Addendum

Fort White Community Center
New Restroom Building
Fort White, Florida

1642

Addendum Number

NORTH ELEVATION

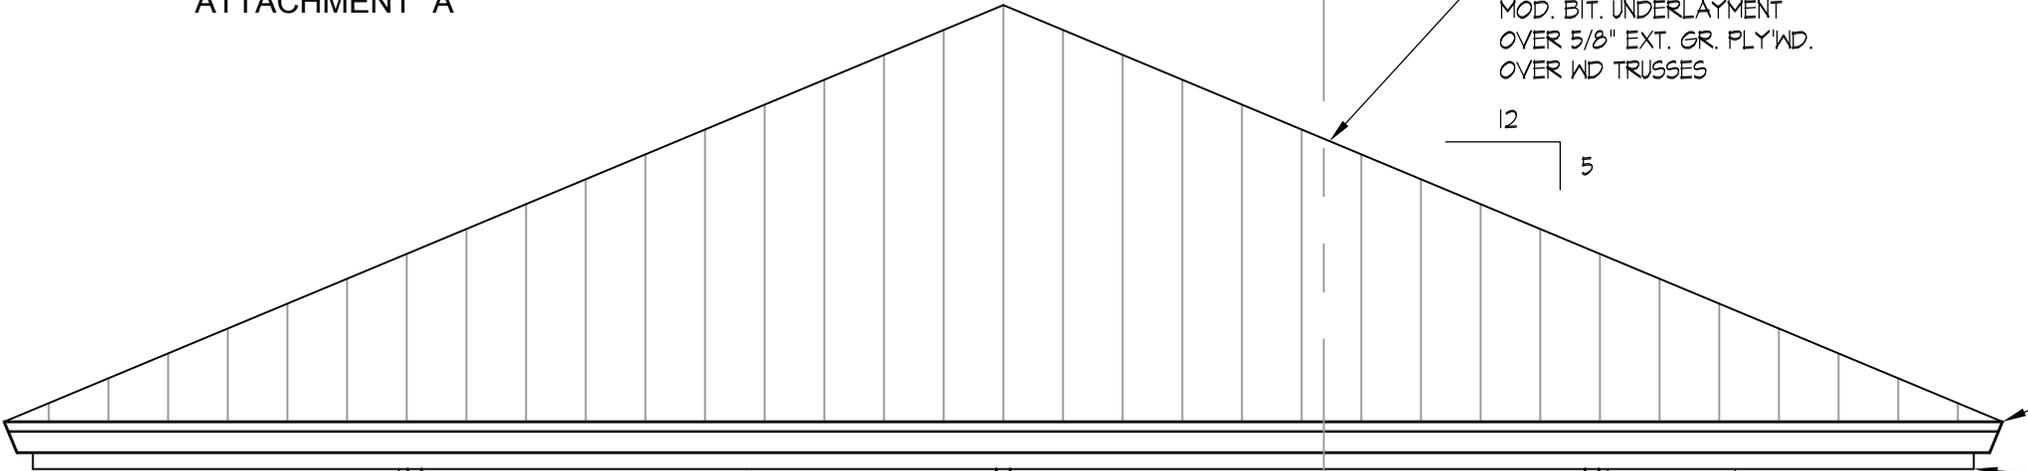
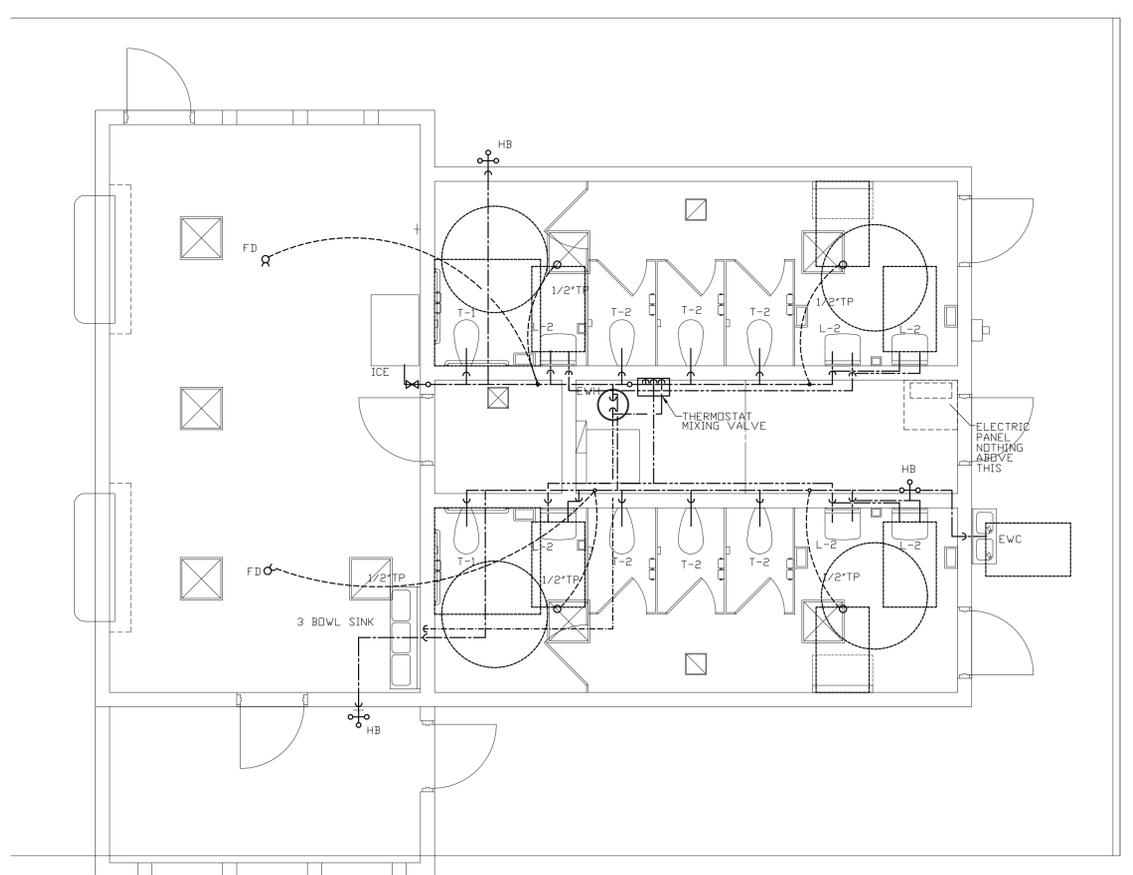
4. **DRAWINGS, SHEET A-3 – EXTERIOR ELEVATIONS:** Refer to Attachment "A" for revisions to the North Elevation. Provide regular (painted) smooth surfaced CMU where the drinking fountain is installed.

AREA OF REGULAR
(PAINTED) SMOOTH
SURFACED CMU AT
DRINKING FOUNTAIN

SANITARY PLAN
1/4" = 1'-0"

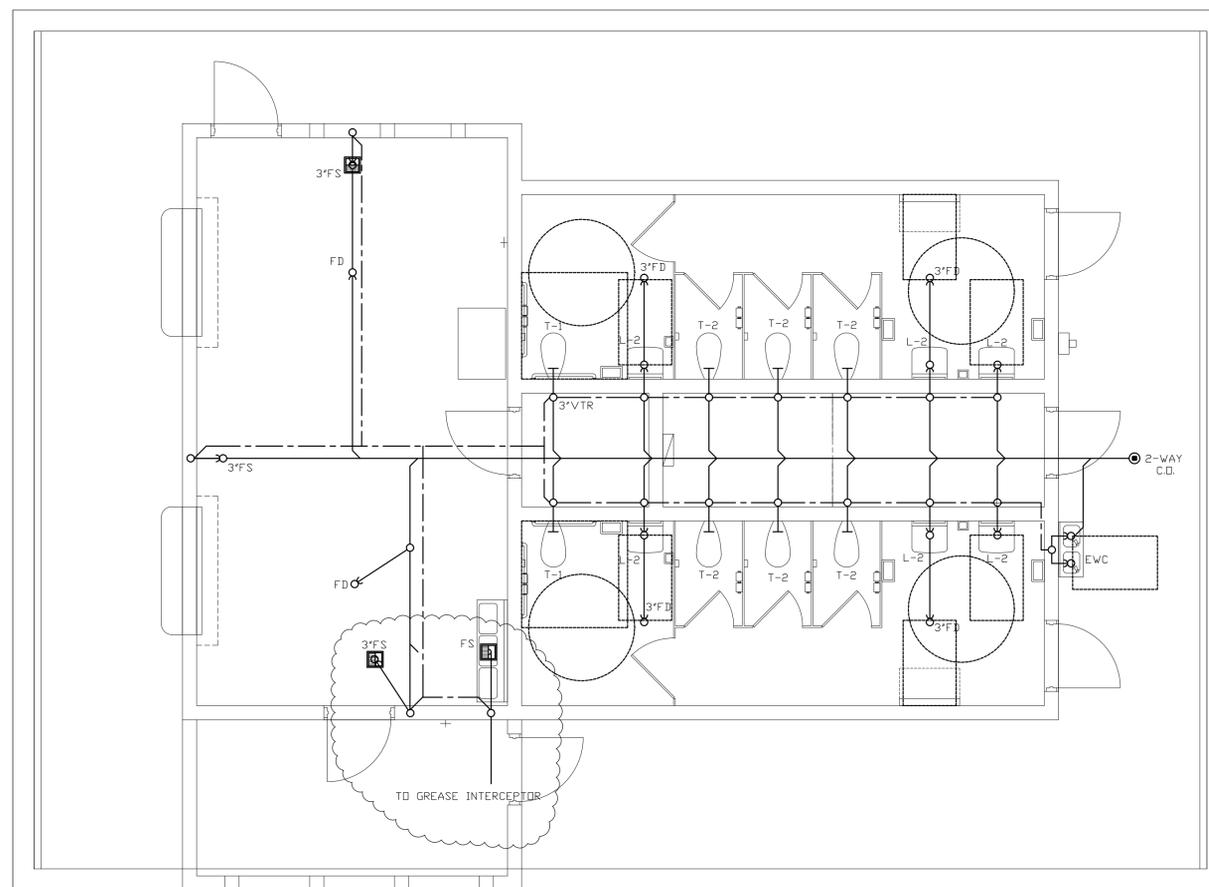
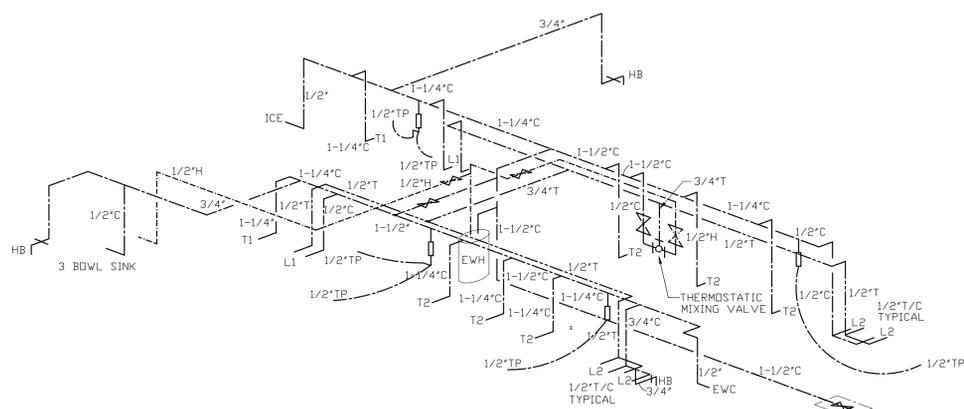
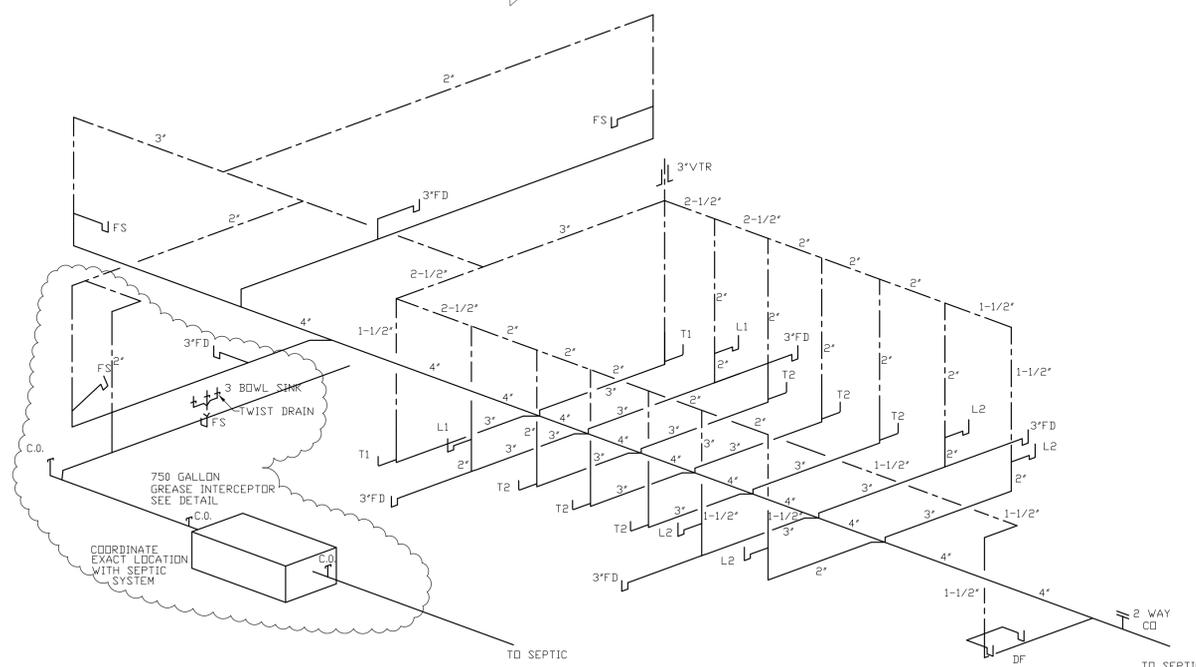
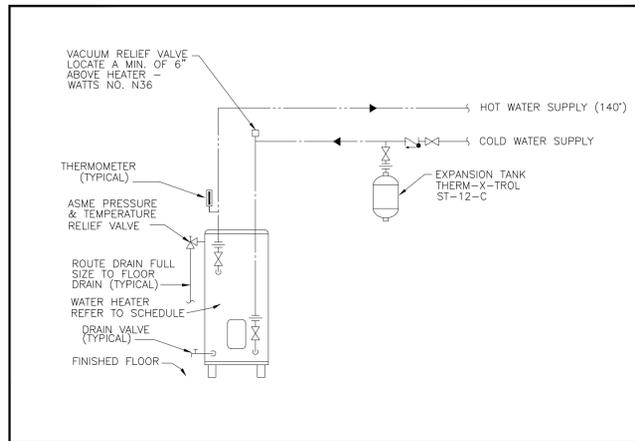
7. **DRAWINGS, SHEET M1 – HVAC PLAN:** Change the Type A diffuser to a Titus Model.
8. **DRAWINGS, SHEETS P1 AND P2 – SUPPLY PLAN, SANITARY PLAN AND RISERS, DETAILS AND SCHEDULES:** Add grease interceptor and revise the sanitary piping as shown on the attached revised Sheets P1 and P2.
